SERVICE BULLETIN

M-1183

Safety Recall Code 0124

SAFETY RECALL 0124-2006 DYNA TRANSMISSION

Figure 7. Primary Chaincase Housing

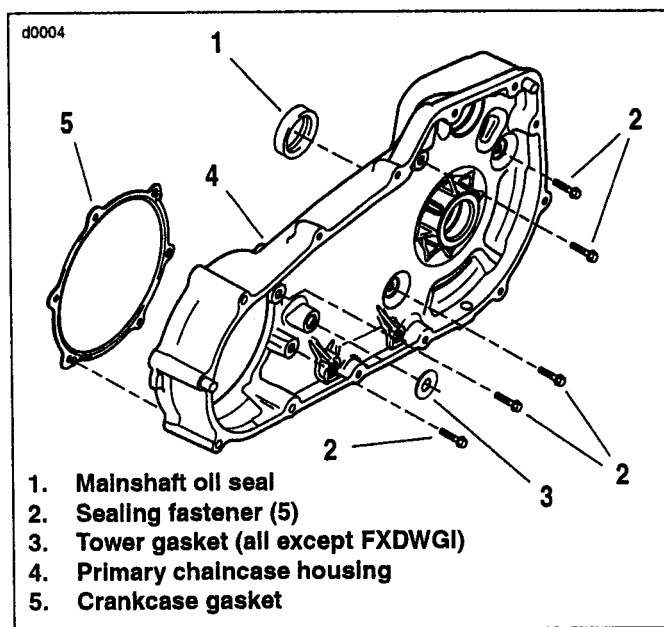
13. See Figure 7. Remove five sealing fasteners (2) securing primary chaincase housing (4) to engine crankcase and transmission. Remove primary chaincase housing from vehicle. Discard crankcase gasket (5).
14. Remove seal protector sleeve (or tape) from mainshaft splines.

Figure 9. Transmission Gear Assembly with Shift Forks and Shift Cam

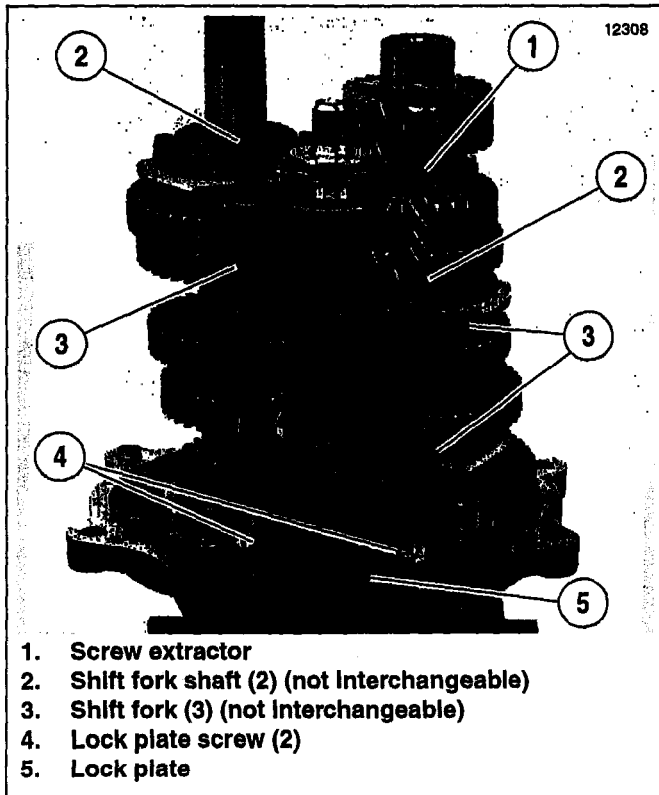
20. See Figure 9. With access door on end (shafts pointing upward), remove shift fork shafts (2) using screw extractor—not flute design (1). Shafts have slight interference fit. Shafts can be reused; do not damage end of shaft. Do not remove shift forks from shift fork shafts. Remove each shaft and shift fork(s) as a unit.
21. Remove two screws (4) and lock plate (5). Discard screws.

4. See Figure 9. Install lock plate (5) and new lock plate screws (4) (Part No. 35259-06 from 94445 recall parts kit) into transmission bearing housing. Tighten screws to 50-70 In-lbs (5.7-7.9 Nm).
5. See Figure 12. Make certain shift forks and shafts are assembled as shown.

Figure 10. Shift Cam and Detent Assembly

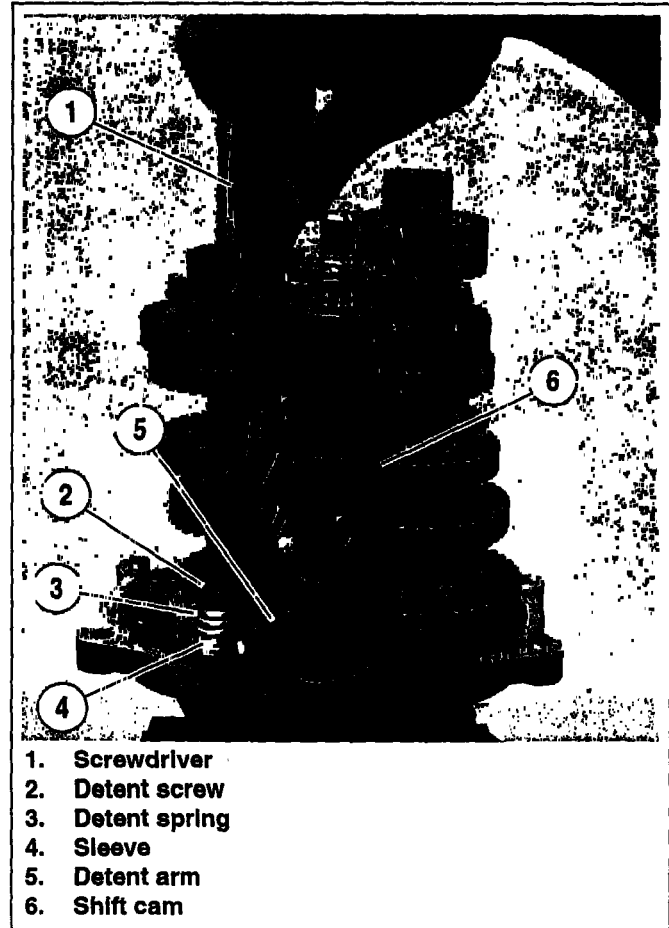
22. See Figure 10. Insert screwdriver (1) and gently pry back detent arm (5) to remove detent spring (3) tension from shift cam (6). Remove shift cam.
23. Remove detent screw (2), detent spring, sleeve (4) and detent arm. Discard detent screw.

3. See Figure 10. Using screwdriver (1), pull detent arm (5) back and install new shift cam (6) (Part No. 33413-06 from 94445 recall parts kit).

Figure 11. Detent Assembly

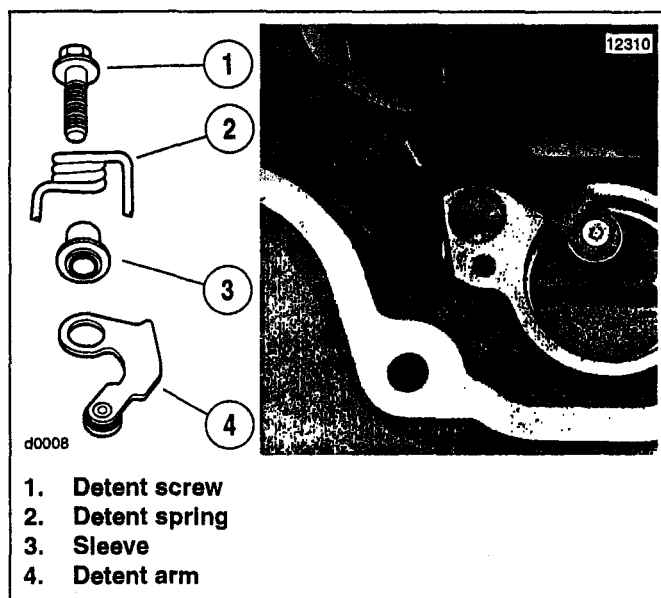
- Clean the following threaded holes:
 - shift cam lock plate mounting holes in transmission bearing housing,
 - detent screw mounting hole in transmission bearing housing.
- See Figure 11. Assemble new detent screw (1) (Part No. 35244-06 from 94445 recall parts kit), detent spring (2), sleeve (3) and new detent arm (4) (Part No. 33409-06 from 94445 recall parts kit). With transmission bearing housing mounted on end (shafts pointing upward), mount detent assembly in bearing housing as shown. Make certain to orient spring and detent arm as shown in the figure. Tighten screw to 120-150 in-lbs (13.6-17.0 Nm).

Figure 14. Installing Mainshaft Inner Bearing Race

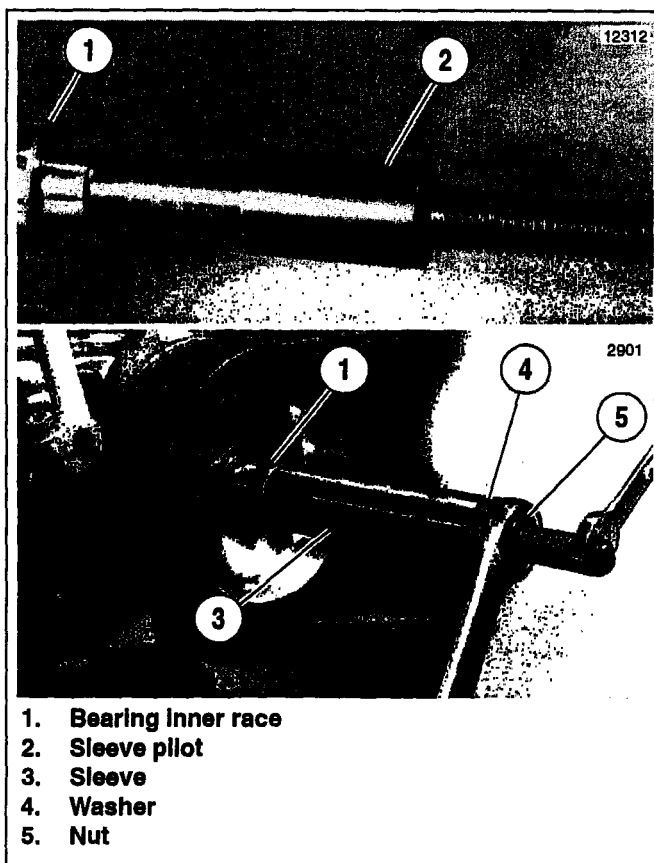
*See Figure 14. The **new** mainshaft inner bearing race (Part No. 34091-06 from 94445 recall parts kit) must be positioned on the mainshaft a precise distance to properly align with bearing outer race in inner primary chaincase.*

Do NOT press the inner race all the way against the main drive gear. If the inner race is pressed against the main drive gear, the inner race will be out of alignment with the bearing in the primary housing. This can result in premature bearing failure.

17. See Figure 14. To install **new** mainshaft bearing inner race (1) (Part No. 34091-06 from 94445 recall parts kit), use those parts of the combination BEARING RACE PULLER AND INSTALLATION TOOL (Part No. HD-34902-B) that are shown in the figure.
 - a. Slide bearing inner race (1) onto mainshaft with numbered end of race facing away from main drive gear.
 - b. Thread sleeve pilot (2) onto end of mainshaft (left hand thread).
 - c. Position sleeve (3) over sleeve pilot and against bearing inner race.

- d. Place washer (4) over threaded portion of sleeve pilot and install nut (5).
- e. Tighten nut while holding sleeve pilot stationary with wrench on flats at end of screw threads. Press bearing inner race onto shaft so inside edge is 0.100-0.125 in. (2.540-3.180 mm) from main drive gear.

Figure 17. Sealing Fastener (Part No. 786A)

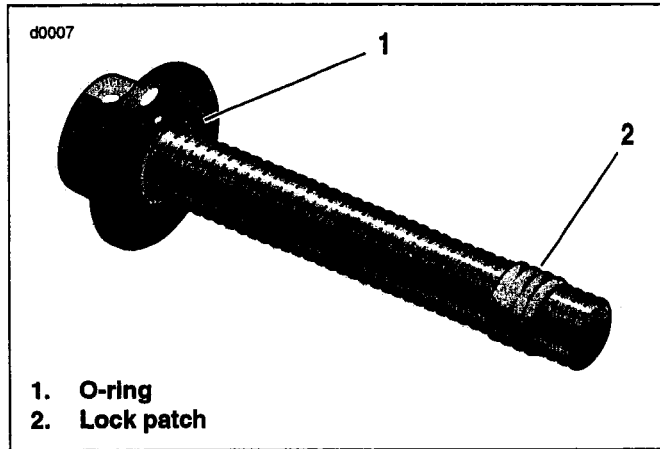
See Figure 17. **New sealing fasteners (Part No. 786A from 94445 recall parts kit) have different head markings and are 1/8 in. longer than old fasteners. New fasteners also have an orange lock patch.**

Figure 18. Sealing Fastener Tightening Sequence

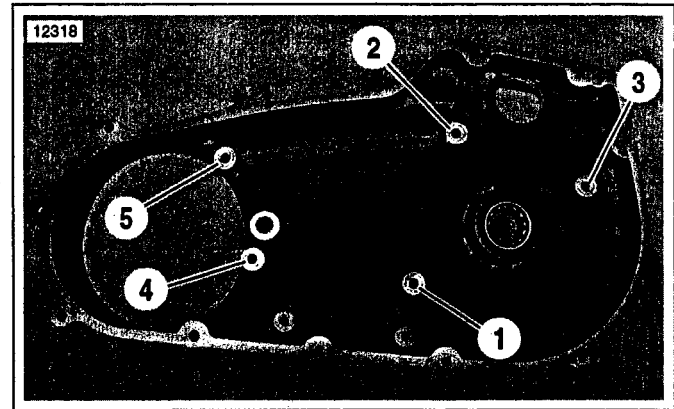
32. See Figure 18. Clean the faces of the five mounting screw bosses in the inner primary housing with PJ1 or equivalent. The boss faces must be clean and dry, free of any oil or other contaminants.
33. Insert five **new** sealing fasteners (Part No. 786A from 94445 recall parts kit). Start all five fasteners in holes. Then tighten fasteners in the sequence shown in the figure to 27 ft-lbs (36.6 Nm).
34. Remove seal protector sleeve (or tape) from transmission mainshaft splines.
35. Attach starter motor assembly to inner primary housing with two screws and washers. Tighten to 13-20 ft-lbs (17.6-27.1 Nm). See INSTALLATION under 5.4 STARTER in DYNA MODELS SERVICE MANUAL.
36. Clean the following fastener threads and threaded holes.
 - compensating sprocket bolt,
 - engine sprocket shaft threaded hole,
 - transmission mainshaft threads,
 - clutch hub mainshaft locknut.
